**Review of NIOSH Response to SC&A Comments on
ORAUT-RPRT-0090 re Monitoring Feasibility Evaluation for
Exotic Radionuclides Produced by the Oak Ridge National
Laboratory Isotopes Division**

**Contract No. 75D30119C04183
Document No. SCA-TR-2020-SEC007, Revision 0**

January 8, 2021

Figure 2. Commercial radioiodine production (1945–1962) (reproduced from SC&A (2018), figure 2)

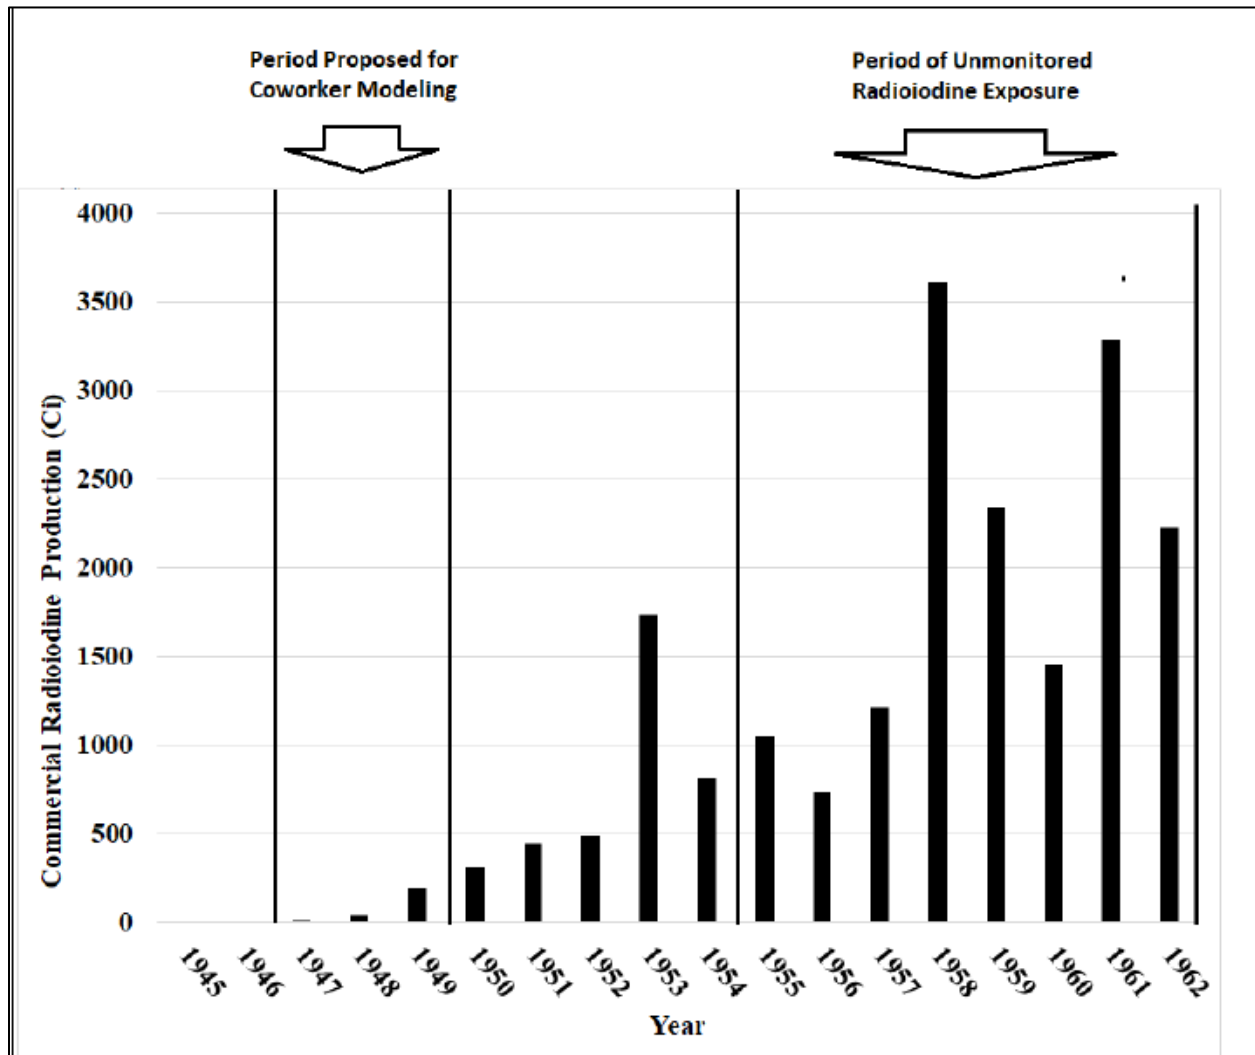
SC&A respectfully disagrees. In a general programmatic view, it is SC&A’s opinion that the question of representativeness of co-exposure models includes an evaluation of the operational conditions at the time. This is of particular importance when data are extrapolated from one operational period to another. SC&A’s interpretation of the guidance in DCAS-IG-006, “Criteria for the Evaluation and Use of Co-Exposure Datasets” (NIOSH, 2020b), requires even stricter evaluation of such operational conditions when combining data from contiguous years. Specifically, NIOSH (2020b, p. 11) states:

SC&A believes such an evaluation is especially applicable when extrapolating data from one period to another.

The contention that workers were not “exposed to levels of activity that would have triggered the monitoring program” is not currently able to be evaluated because sufficient monitoring data from this period have not been located. SC&A believes the claimant-favorable assumption is that the lack of monitoring data during the period of interest is not due to a lack of exposure potential, but rather a lack of available records.

Specific to the co-exposure period in question, the major difference in campaigns appears to be related to the commercial production of radioiodine. It is SC&A’s understanding that, while such commercial operations are not necessarily included in EEOICPA DRs, if it is not possible to differentiate between Atomic Weapons Employer/DOE operations and commercial operations, they must be considered for DR. Therefore, it is unclear to SC&A whether the difference in commercial operations as demonstrated in figure 2 of SC&A (2018) (shown below in figure 2) is relevant in an SEC context. A clarification of the statutory requirements concerning “commercial” versus “government” work may render this observation moot for the purposes of developing DR methods.
